TA21

SITE SUMMARY

Site Name: Technical Area 21 (DP Canyon)
 Location: Los Alamos National Laboratory (LANL)
 Project Mgr: Anthony Moreland
 Consultant: LANL
 Site Priority: #751 on Third Priority List
 Brief History: DP TANK Farm 21-029

LANL 21/2
Information to date

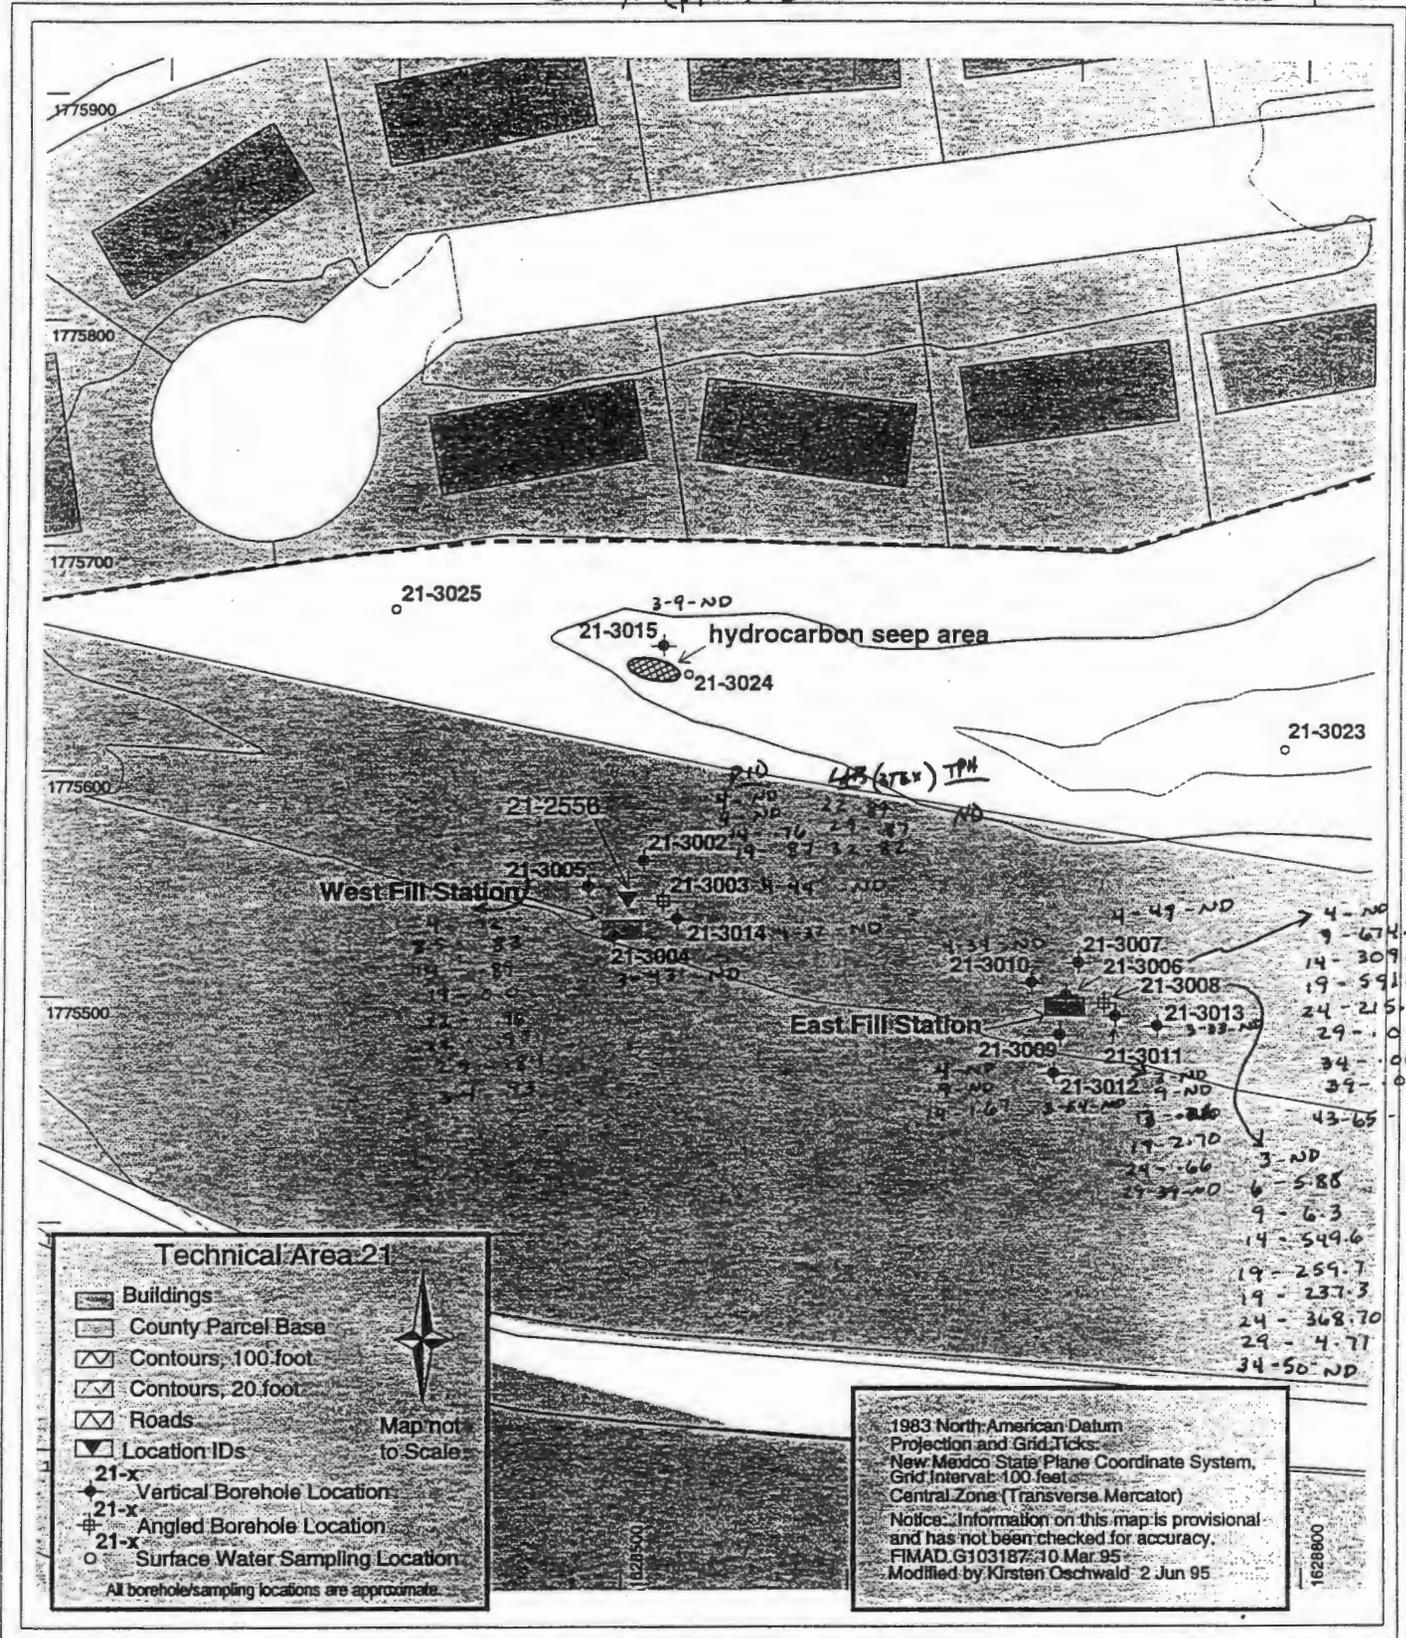
- HS - hits 10'-15' east of fill station south side
of pit (Did not show vertical)
- B - 1 hit @ 30' in center of pit (2.794) OK
- BTEX - 1 hit above 50 ppm @ 30' in center of pit
(224 ppm) (did not show vertical)
- TPH - several hits, pit down to 32' up to 8000 ppm
(did not show vertical)

did not show vertical for TPH but did show
horizontal

Need to look at tank area
Need to look at lines
Need to look at dispensers

Those three things besides not defining vertical in pits

Not NFA because need to look at other aspects listed above
